SPRINGFIELD STATE AIRPORT

TERMINAL AREA IMPROVEMENTS

ADAP NO. 5-50-0016-04

AS BUILT PLANS

LIGHTING PLAN

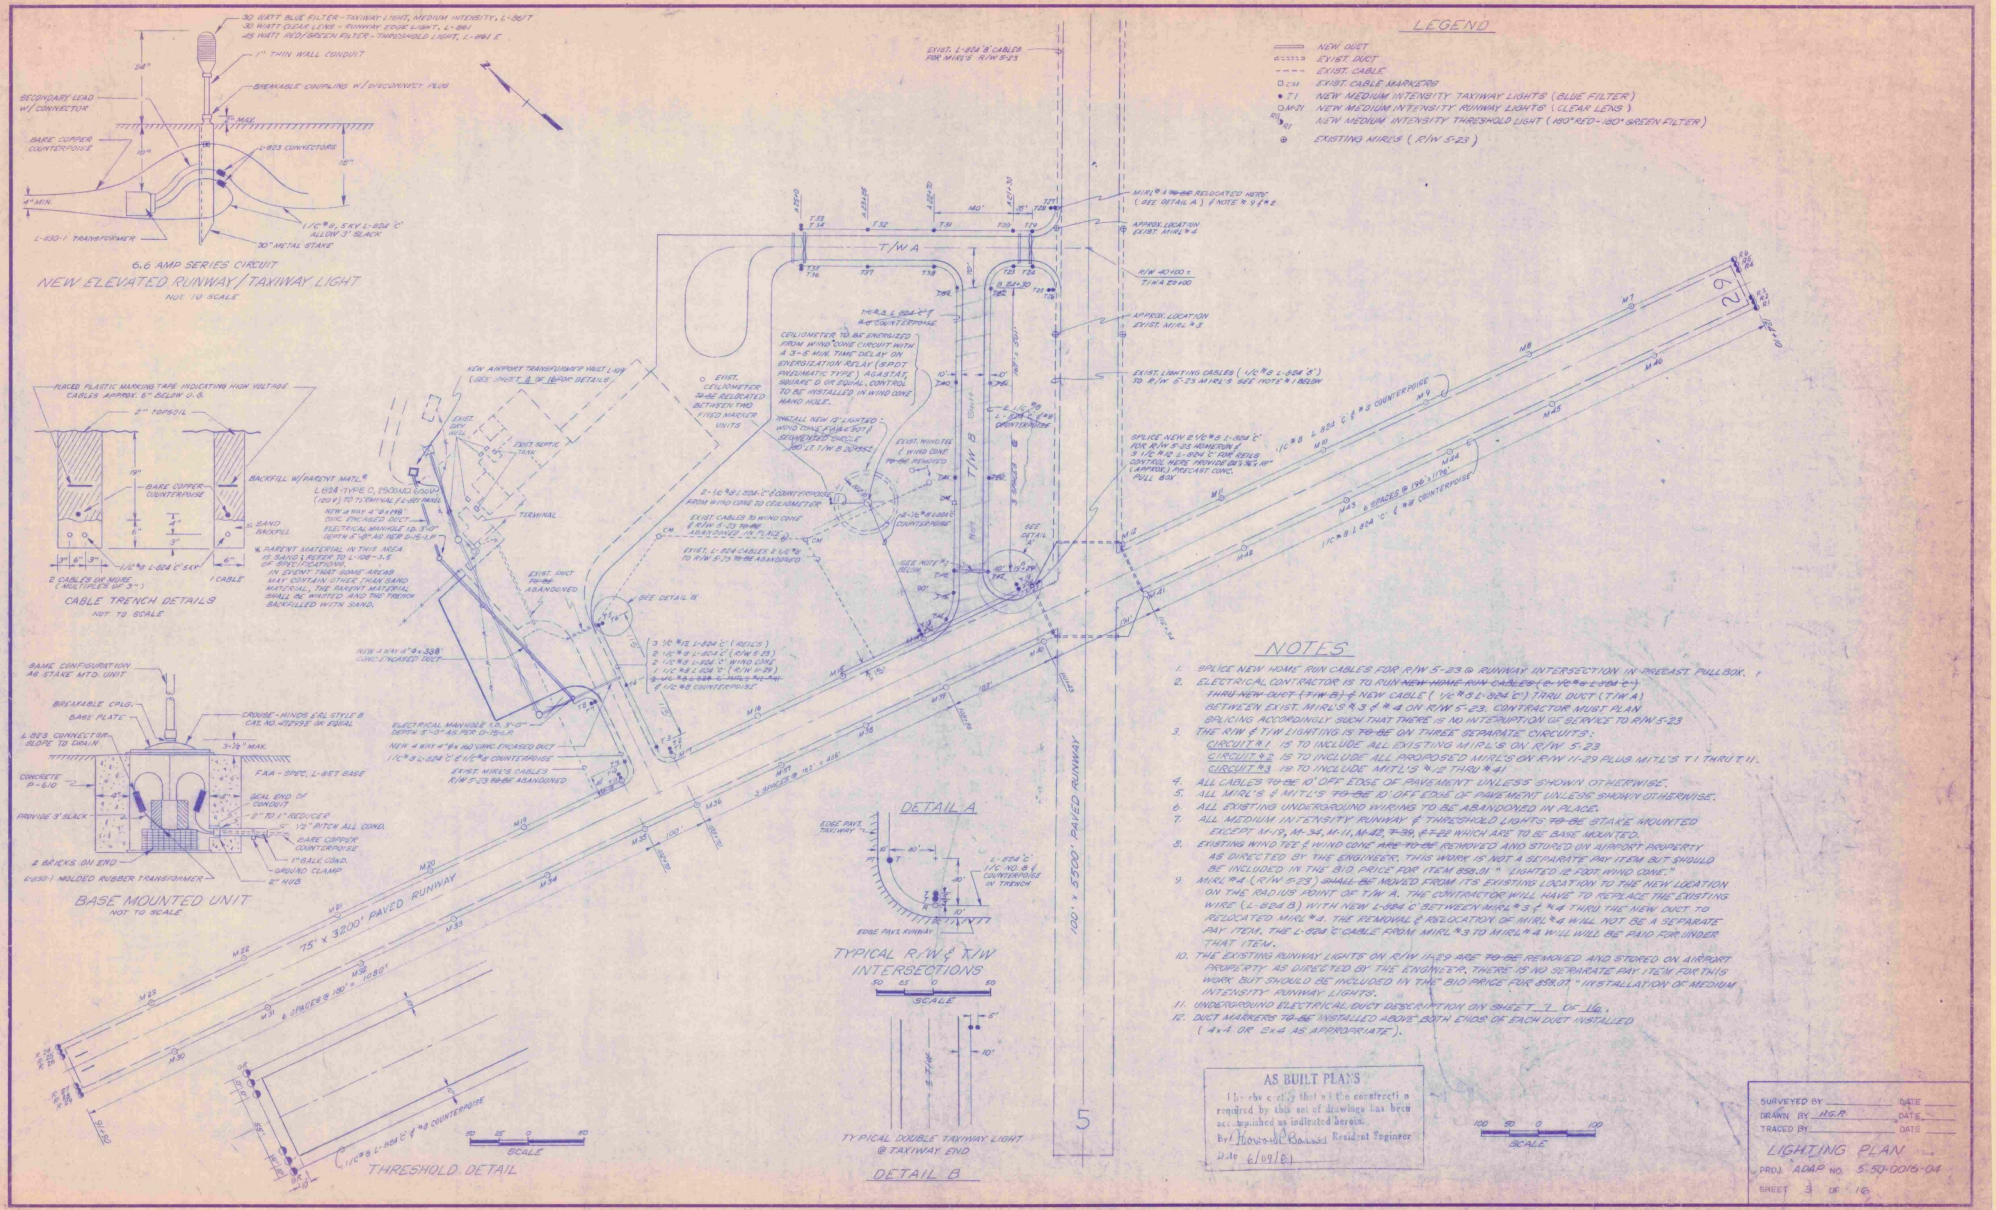
1. SPLICE NEW HOME RUN CABLE'S FOR R/W 5-23 @ RUNWAY INTERSECTION IN PRECAST PULLBOX.
2. ELECTRICAL CONTRACTOR IS TO RUN ~~NEW HOME RUN CABLES (1-1/C #8 & 1-L-824 C)~~ THRU NEW DUCT (T/W B) & NEW CABLE (1/C #8 L-824 'C') THRU DUCT (T/W A) BETWEEN EXIST. MIRL'S # 3 & # 4 ON R/W 5-23. CONTRACTOR MUST PLAN SPLICING ACCORDINGLY SUCH THAT THERE IS NO INTERRUPTION OF SERVICE TO R/W 5-23

3. THE R/W & T/W LIGHTING IS ~~TO BE~~ ON THREE SEPARATE CIRCUITS:
   CIRCUIT # 1 IS TO INCLUDE ALL EXISTING MIRL'S ON R/W 5-23
   CIRCUIT # 2 IS TO INCLUDE ALL PROPOSED MIRL'S ON R/W 11-29 PLUS MITL'S T1 THRU T11.
   CIRCUIT # 3 IS TO INCLUDE MITL'S # 12 THRU # 41

4. ALL CABLES ~~TO BE~~ 10' OFF EDGE OF PAVEMENT UNLESS SHOWN OTHERWISE.
5. ALL MIRL'S & MITL'S ~~TO BE~~ 10' OFF EDGE OF PAVEMENT UNLESS SHOWN OTHERWISE.

6. ALL EXISTING UNDERGROUND WIRING TO BE ABANDONED IN PLACE.
7. ALL MEDIUM INTENSITY RUNWAY & THRESHOLD LIGHTS ~~TO BE~~ STAKE MOUNTED EXCEPT M-10, M-34, M-11, M-42, ~~T-39~~, ~~& T-28~~ WHICH ARE TO BE BASE MOUNTED.

8. EXISTING WIND TEE & WIND CONE ~~ARE TO BE~~ REMOVED AND STORED ON AIRPORT PROPERTY AS DIRECTED BY THE ENGINEER. THIS WORK IS NOT A SEPARATE PAY ITEM BUT SHOULD BE INCLUDED IN THE BID PRICE FOR ITEM 858.01 " LIGHTED 12 FOOT WIND CONE."

9. MIRL # 4 (R/W 5-23) ~~SHALL BE~~ MOVED FROM ITS EXISTING LOCATION TO THE NEW LOCATION ON THE RADIUS POINT OF T/W A. THE CONTRACTOR WILL HAVE TO REPLACE THE EXISTING WIRE (L-824 B) WITH NEW L-824 C BETWEEN MIRL # 3 & # 4 THRU THE NEW DUCT TO RELOCATED MIRL # 4. THE REMOVAL & RELOCATION OF MIRL # 4 WILL NOT BE A SEPARATE PAY ITEM. THE L-824 'C' CABLE FROM MIRL # 3 TO MIRL # 4 WILL BE PAID FOR UNDER THAT ITEM.

10. THE EXISTING RUNWAY LIGHTS ON R/W 11-29 ARE ~~TO BE~~ REMOVED AND STORED ON AIRPORT PROPERTY AS DIRECTED BY THE ENGINEER. THERE IS NO SEPARATE PAY ITEM FOR THIS WORK BUT SHOULD BE INCLUDED IN THE BID PRICE FOR 858.01 " INSTALLATION OF MEDIUM INTENSITY" RUNWAY LIGHTS.

11. UNDERGROUND ELECTRICAL DUCT DESCRIPTION ON SHEET 7 OF 16.
12. DUCT MARKERS ~~TO BE~~ INSTALLED ABOVE BOTH ENDS OF EACH DUCT INSTALLED (1x4 OR 2x4 AS APPROPRIATE).

ELECTRICAL TYPICALS & VAULT WIRING DIAGRAM

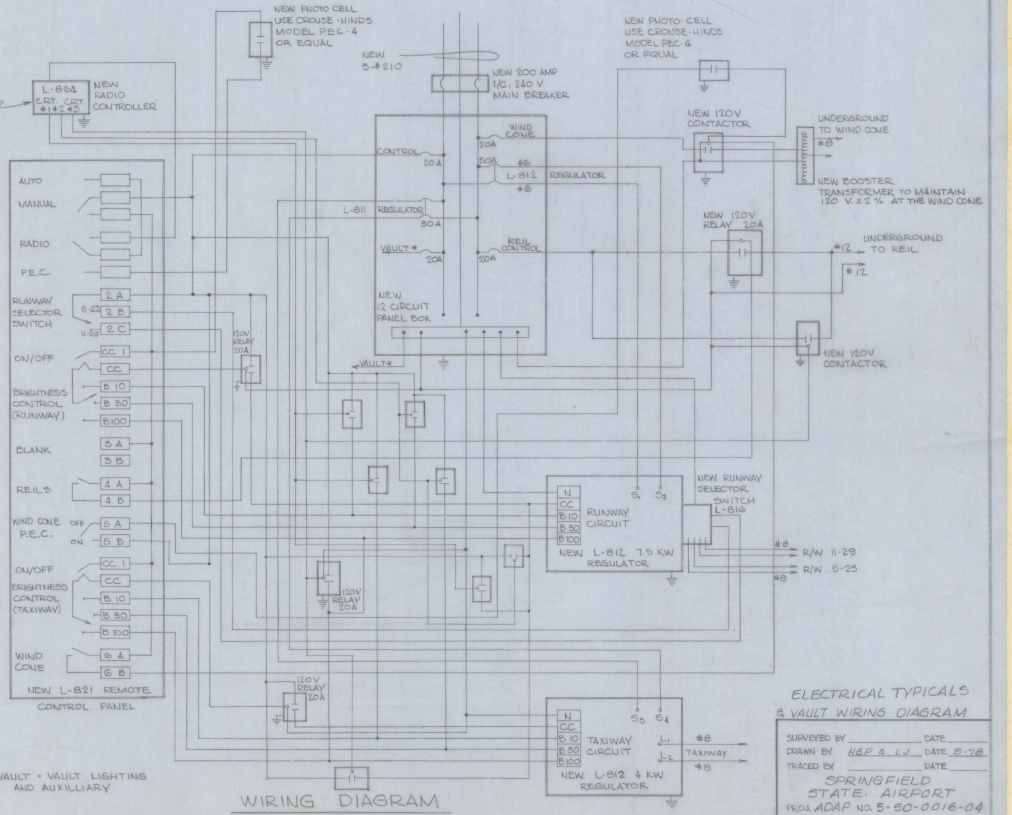
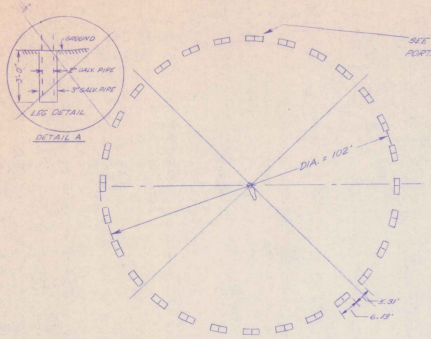
3. L-821 (REMOTE CONTROL PANEL) ~~TO BE~~ MOUNTED IN EXISTING TERMINAL AT THE DIRECTION OF THE ENGINEER. ALL OTHER ELECTRICAL EQUIPMENT ~~TO BE~~ MOUNTED IN NEW ELECTRICAL VAULT (SEE DIAGRAM BELOW).

4. ALL WIRING #12 AWG UNLESS NOTED OTHERWISE.
5. EXISTING 4 KW REGULATOR (IN TERMINAL) ~~TO BE~~ REMOVED AND INSTALLED IN NEW VAULT ~~AND STORED ON AIRPORT PROPERTY~~ AS DIRECTED BY THE ENGINEER.

9. ALL CONTACTORS AND RELAYS ~~TO BE~~ ENCLOSED IN NEMA-4 ENCLOSURES.
10. CONTRACTOR (S) SHALL PAINT A REFERENCE MARK ON THE NEW APRON FOR CEILIOMETER READING AT THE LOCATION INDICATED BY THE F.S.O.

ELECTRICAL TYPICALS & VAULT WIRING DIAGRAM

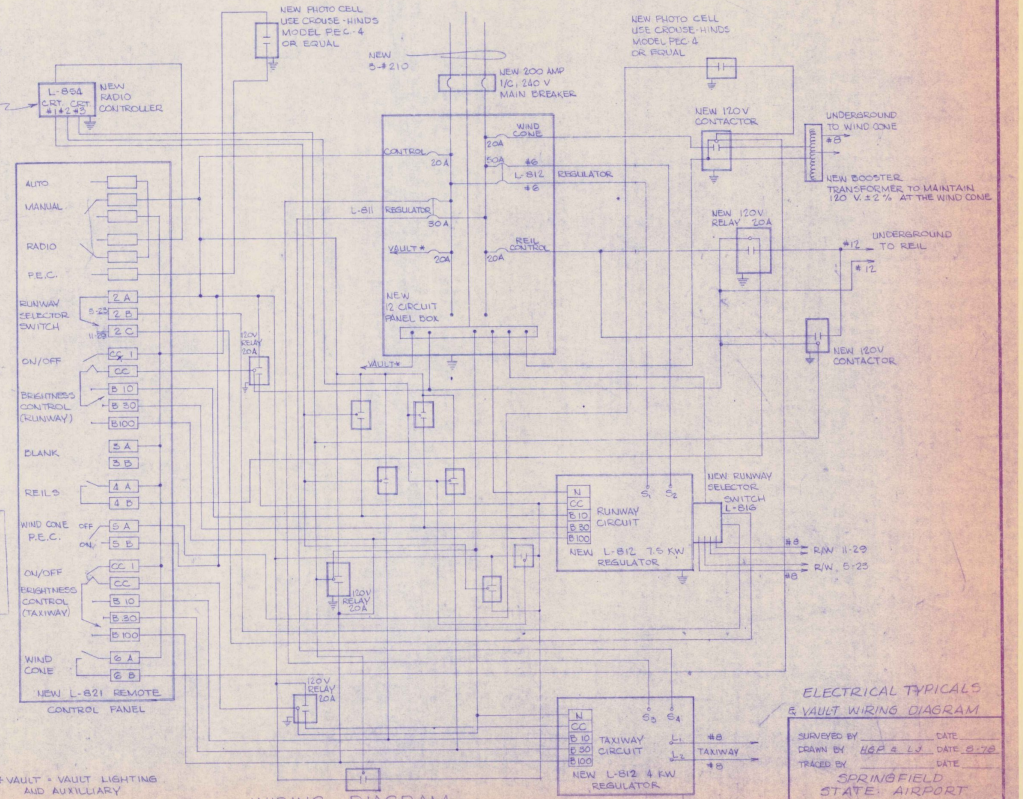
3. L-821 (REMOTE CONTROL PANEL) ~~TO BE~~ MOUNTED IN EXISTING TERMINAL AT THE DIRECTION OF THE ENGINEER. ALL OTHER ELECTRICAL EQUIPMENT ~~TO BE~~ MOUNTED IN NEW ELECTRICAL VAULT (SEE DIAGRAM BELOW).

4. ALL WIRING #12 AWG UNLESS NOTED OTHERWISE.
5. EXISTING 4 KW REGULATOR (IN TERMINAL) ~~TO BE~~ REMOVED AND INSTALLED IN NEW VAULT ~~AND STORED ON AIRPORT PROPERTY~~ AS DIRECTED BY THE ENGINEER.

9. ALL CONTACTORS AND RELAYS ~~TO BE~~ ENCLOSED IN NEMA-4 ENCLOSURES.
10. CONTRACTOR (B) SHALL PAINT A REFERENCE MARK ON THE NEW APRON FOR CEILIOMETER READING AT THE LOCATION INDICATED BY THE F.S.O.

TYPICAL SECTIONS

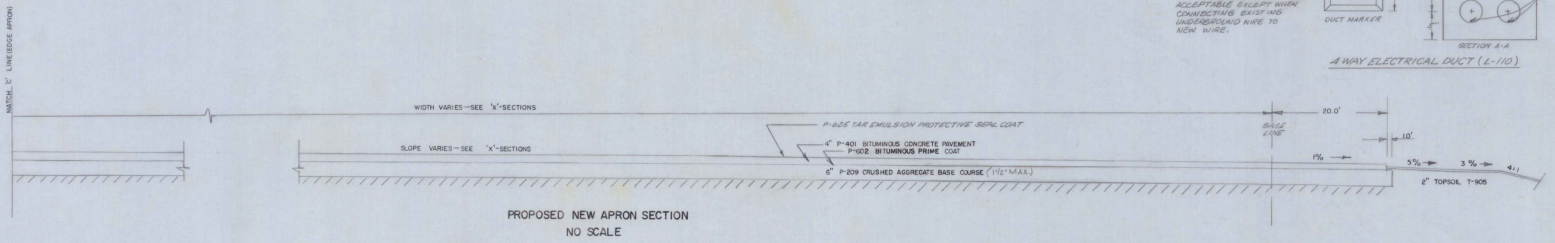
1. COST OF RESTORING SURFACE* TO ITS ORIGINAL CONDITION ~~TO BE~~ INCLUDED IN THE CONTRACTORS BID PRICE PER L.IN.FT. OF ITEM L-101 (INSTALLATION OF AIRPORT UNDERGROUND ELECTRICAL DUCT.)
   * INCLUDES GRAVEL BASE
2. COST OF DUCT MARKERS ~~TO BE~~ INCLUDED IN THE CONTRACTORS BID PRICE PER L.IN. FT. OF ITEM L-110 (INSTALLATION OF AIRPORT UNDERGROUND ELECTRICAL DUCT.)
3. NO HAND LETTERING ON DUCT OR CABLE MARKER.
4. CONDUIT ~~TO BE~~ NON METALLIC RIGID (PLASTIC - PVC) FED. SPEC. W-C-1094 (FAA L-110 TYPE E)
5. CABLE AND SNAKE MARKERS ARE REQUIRED PER FAA SPEC. L-854. SPLICES WILL NOT BE ACCEPTABLE EXCEPT WHEN CONNECTING EXISTING UNDERGROUND WIRE TO NEW WIRE.
